Chapter 9: Slope, Survey, Scaling, and Boundary Defects

Section A — Steep Slopes (Significance & Misclassification)

Section B — Inadequate Site Plan & Partial Boundary Verification (No Stamped Survey of Record)

Figure A1: Poverty Flats Site Plan showing proposed location of cultivation sites in relation to ridge lines and property boundary. Note: None of the cultivation sites are on the top of the ridge lines as claimed in the MND.

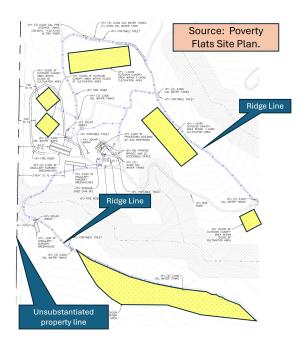
1. The record admits steep terrain—and the site plan's own pad/road placements contradict the "flat ridgetop" claim..

The IS/MND reports an average slope of ~39.5%, and the Property Management Plan describes southern-aspect sloping montane topography—both incompatible with a "flat ridgetop" characterization [A4][A5]. In addition, the site plan locates multiple cultivation pads, access roads, and fencing lines along south- and southwest-facing hillslopes below the ridgeline, with contour spacing that reflects steep grade bands (e.g., 30–50% and greater) rather than level ridgetop benches (Figure A1, A2, A3, A4). Several features would require cut/fill and slope-length breaks to achieve workable grades, which further confirms the on-slope siting. Taken together, the file's own drawings place project elements on steep slopes, directly contradicting the narrative assertion that cultivation areas are "flat, ridgetop areas" and triggering the need for slope-responsive analysis under CEQA. [A11][A12][A4][A5] [A6]

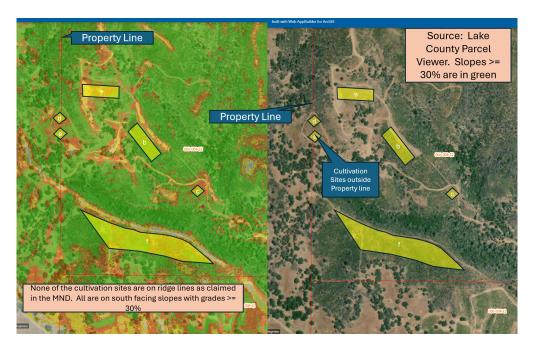
Figure A2: Poverty Flats cultivation sites overlaid onto Lake County Parcel Veiwer maps with slope overlay. Note slopes in green are >=30. Note: viewer-based overlay indicates slopes ≥30%. Viewer alignment suggests Sites "c" and "d" may not be fully inside the parcel; confirmation requires a stamped boundary survey.

6. Parcel-viewer evidence indicates two cultivation sites extend beyond the legal parcel boundary.

Viewer-based overlays indicate areas of close proximity to parcel lines and

potential encroachment for two cultivation sites (Figure A2, A3). Because the western boundary has reportedly been field-verified, uncertainty may be reduced along that edge, but there is no stamped survey of the remaining parcel boundaries or the disturbance polygons. Accordingly, encroachment cannot be confirmed or ruled out without a complete, stamped boundary (and topographic) survey. The County Surveyor has already instructed that Parcel Viewer lines are not acceptable for legal parcel boundaries or setbacks and that a professional survey must control setback measurements. Separately, BLM has required a professional survey to confirm the project's position relative to federal lands. Until a stamped survey demonstrates that each cultivation polygon and associated grading/fencing lies entirely within the legal parcel and outside all required buffers, any "less-than-significant" finding that depends on boundary geometry remains speculative under CEQA.

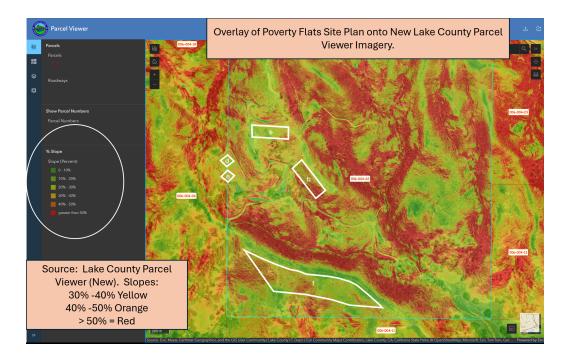
3. ≥50% slopes foreclose Tier-2 enrollment and require denial or an EIR.

The State Water Board's Cannabis Policy prohibits cannabis cultivation or cultivation-related disturbance on slopes ≥50% unless a Regional Water Board issues site-specific WDRs [A16]. The Statewide Cannabis General Order (WQ 2023-0102-DWQ) treats >30% and <50% as Moderate Risk but does not allow Tier-2 enrollment where any portion of the disturbed area is ≥50% [A15][A17]. The record now shows disturbed polygons intersecting ≥50% grades (Figure A3). Because the IS/MND neither discloses nor analyzes a site-specific WDR path—and CEQA forbids post-approval fixes—the Tier-2 premise fails as a matter of law. The appropriate action is to deny the Major Use Permit. If the applicant wishes to pursue any alternative regulatory pathway (including site-specific WDRs or any relocated design to address ≥50% slopes), that would be a new or substantially revised project that must proceed by EIR, not by this IS/MND. [A15][A16][A17]

Figure A3: Poverty Flats cultivation sites overlaid onto Newer version of Lake County Parcel Viewer maps with slope overlay providing more detail. Slopes in yellow are 30% to 40%; Orange 40%-50%; Red > 50%. Sites "b" and "f" are intersecting slopes >50% -- not allowed by WCB. Also Sites "b" and "f" intersect ≥50% slopes under the viewer-based overlay (not allowed by Water Board Tier-2). Viewer alignment also suggests Sites "c" and "d" may not be fully within the parcel; this cannot be confirmed or ruled out without a stamped boundary survey.
